RHODE ISLAND DEPARTMENT OF TRANSPORTATION

RHODE ISLAND CONTRACT NO.2019-CT-099

HSIP - Crosswalk & Sign Enhancements

NOTICE TO PROSPECTIVE BIDDERS

i. Sheet 8, Details

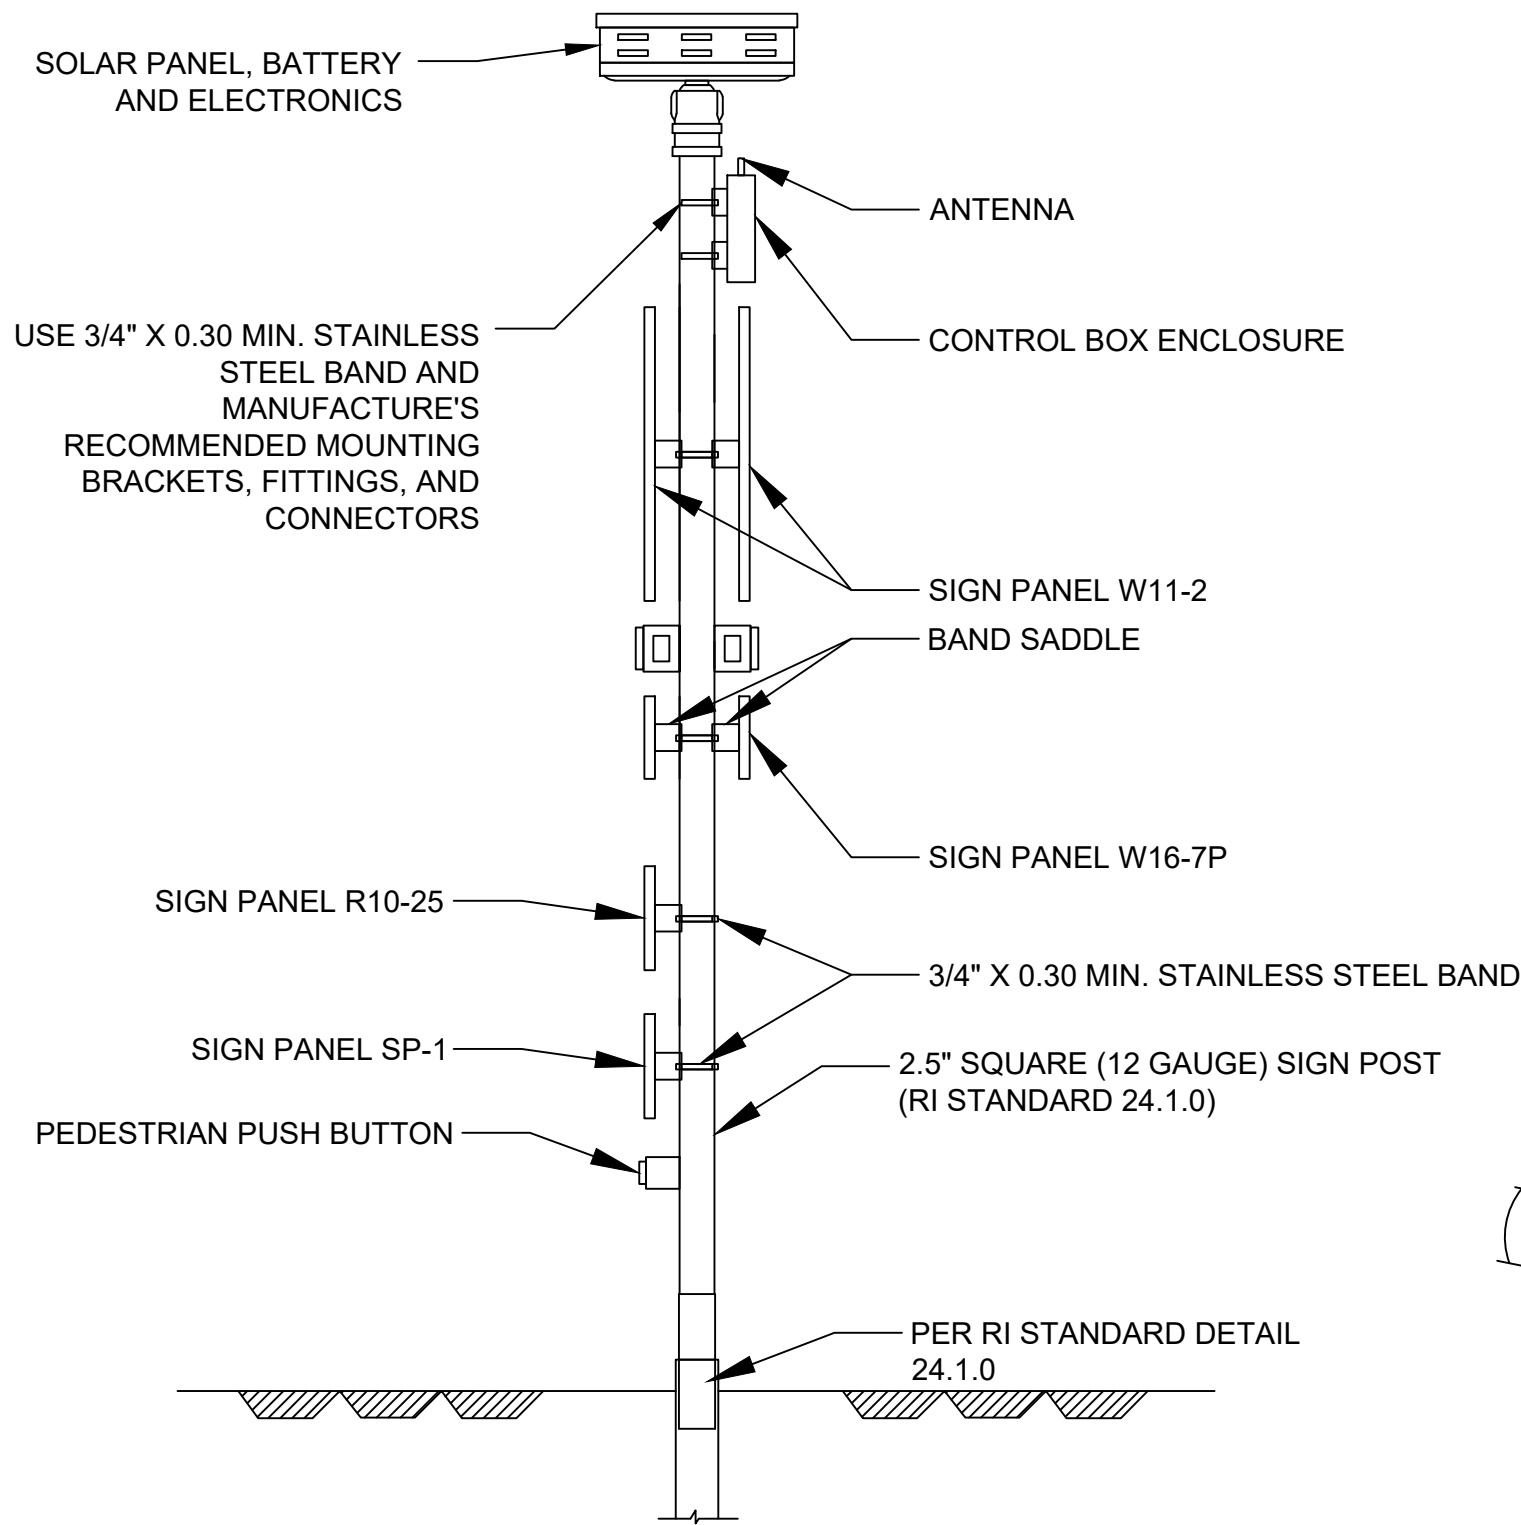
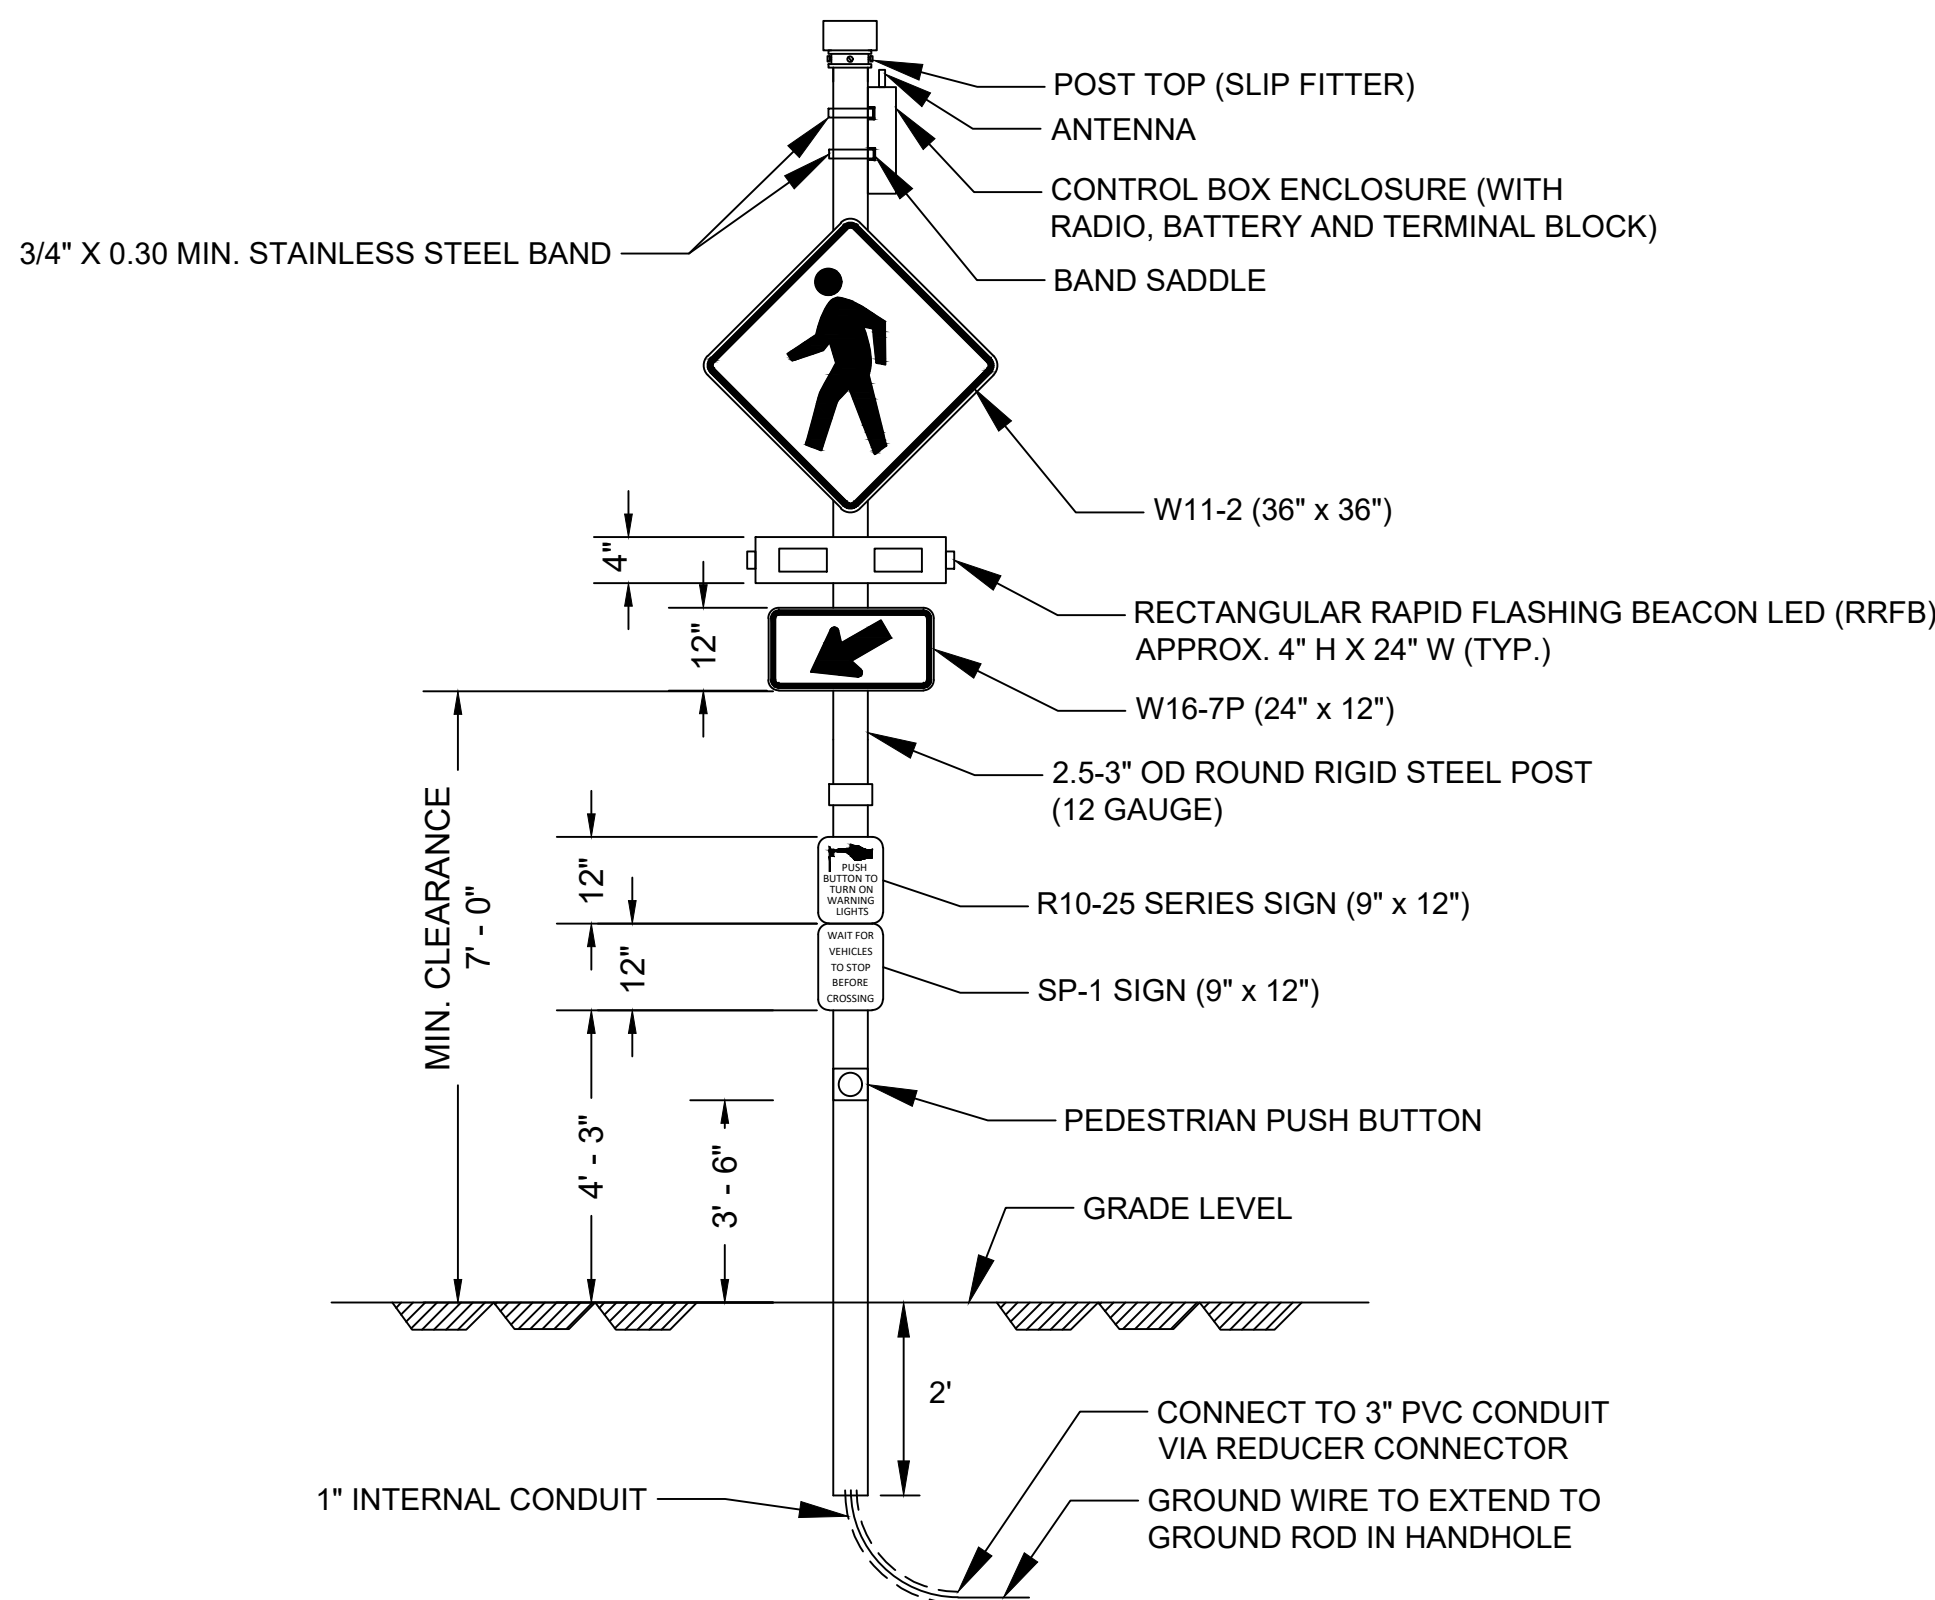
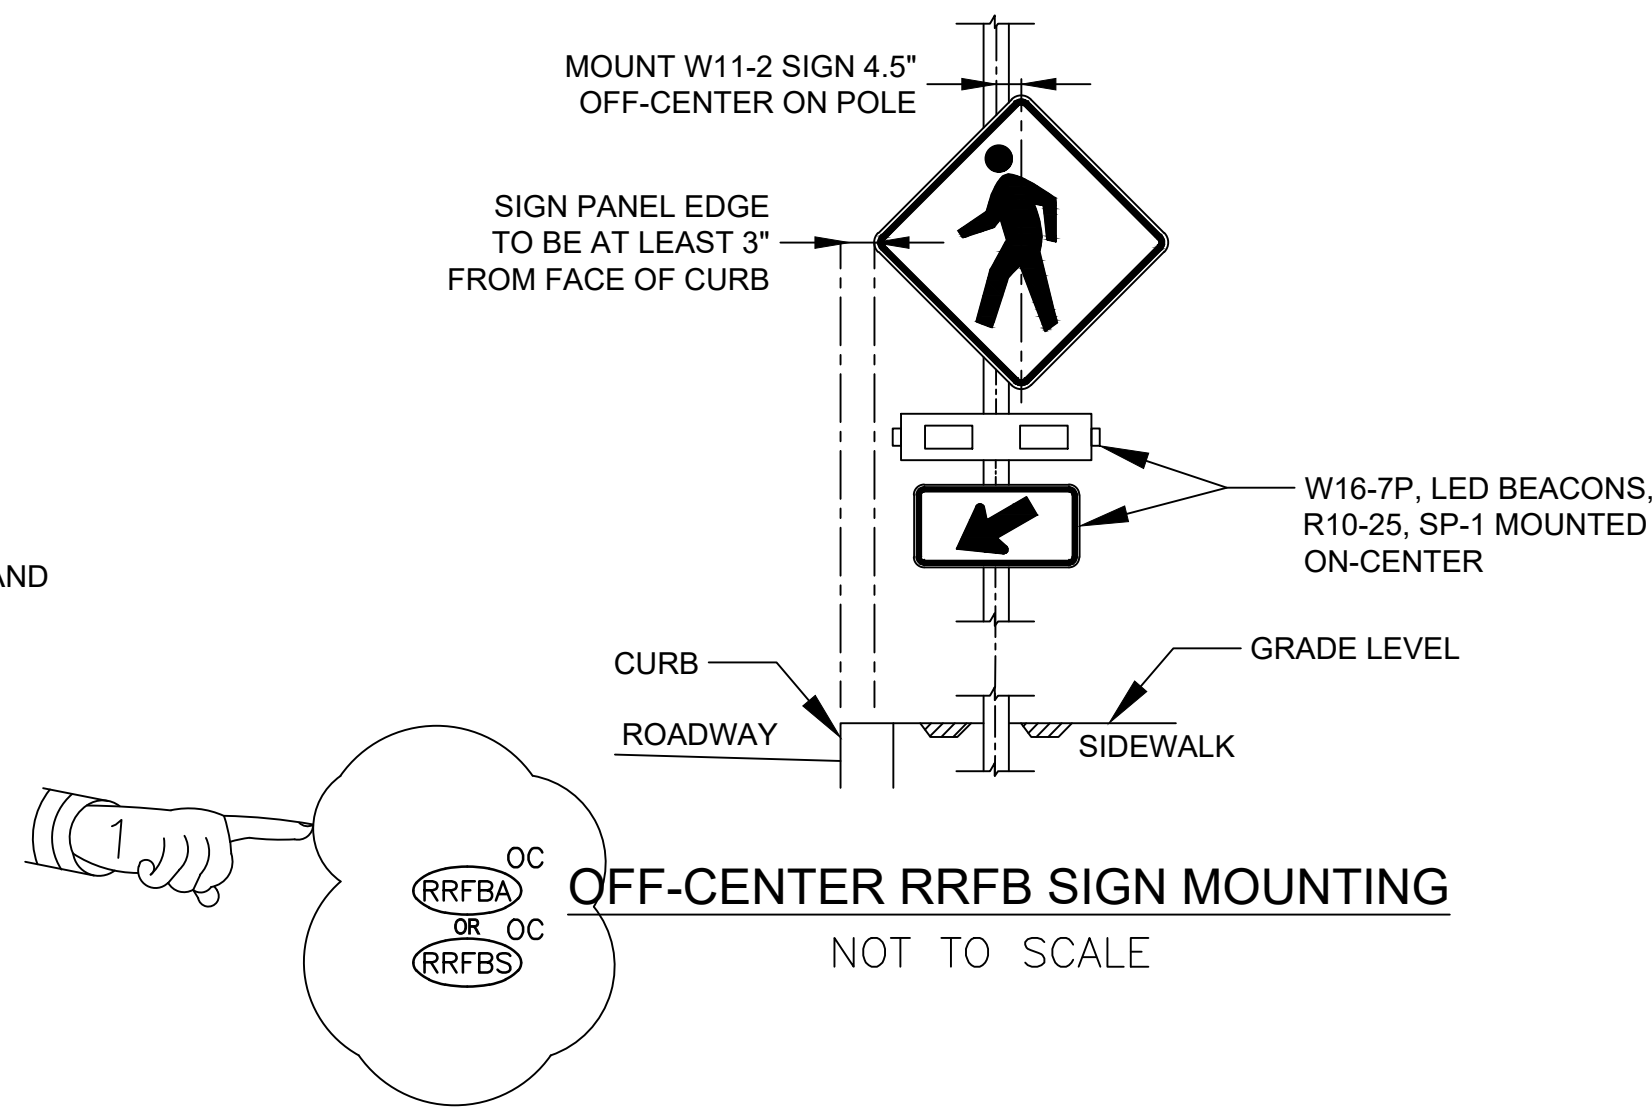
Delete Sheet No. 8 in its entirety and replace with Sheet No. 8 (R-1), attached to this Addendum No.1. The detail for Off-Center RRFB Sign Mounting was revised.
